## Architectural Commission Report

**Subject:** **Wellness Wave**  
**455 North Roxbury Drive**  
Request for approval of a façade remodel, and business identification sign. The Commission will also consider adoption of a Categorical Exemption, pursuant to the California Environmental Quality Act. (PL1408530)

**Project agent:** Erik Link – Architect

**1 PROPOSED SIGNAGE**

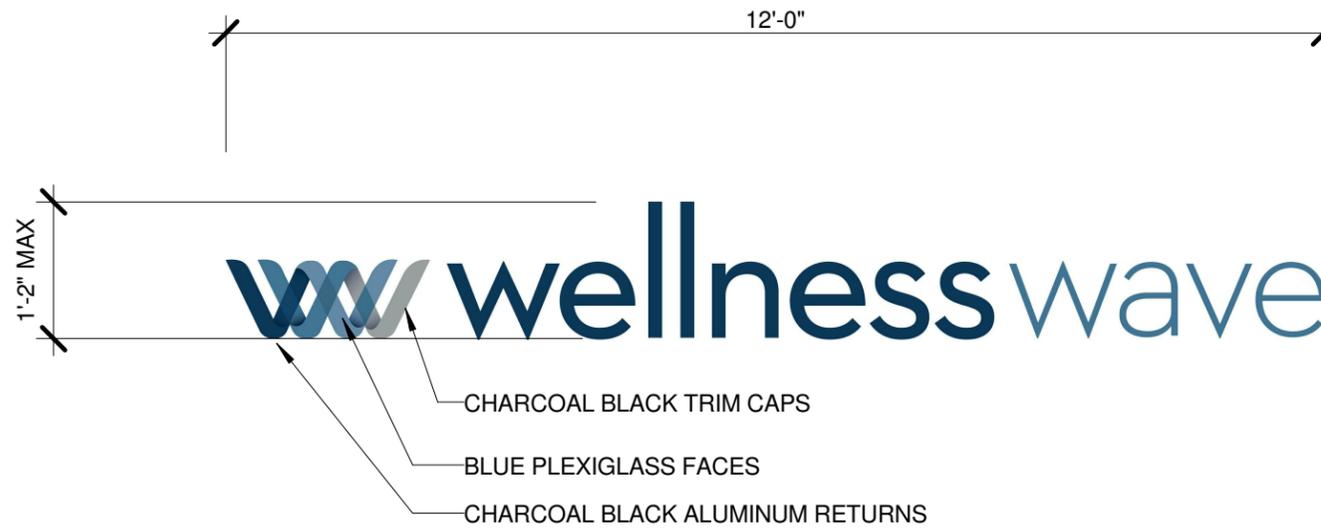
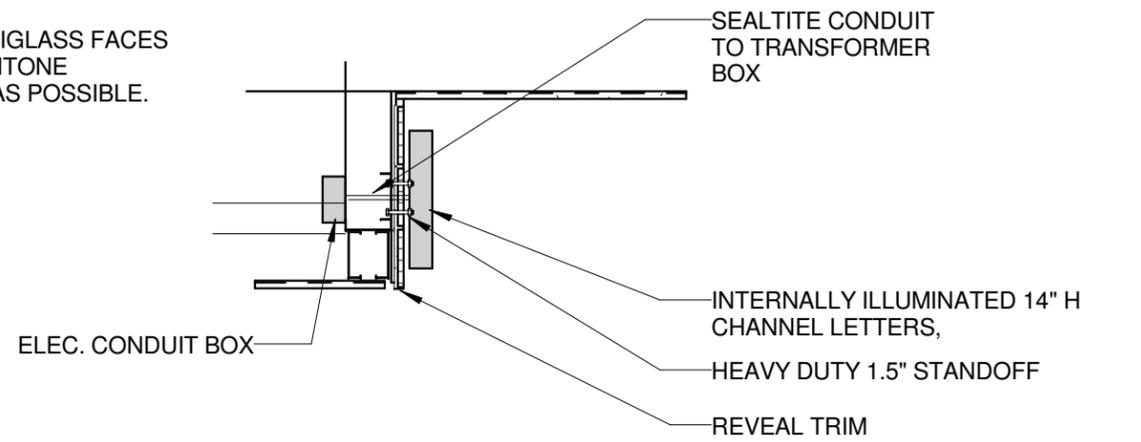
Staff would recommend individual pin-mounted halo or reverse channel letters in aluminum or stainless steel to upgrade the appearance of the proposed sign.
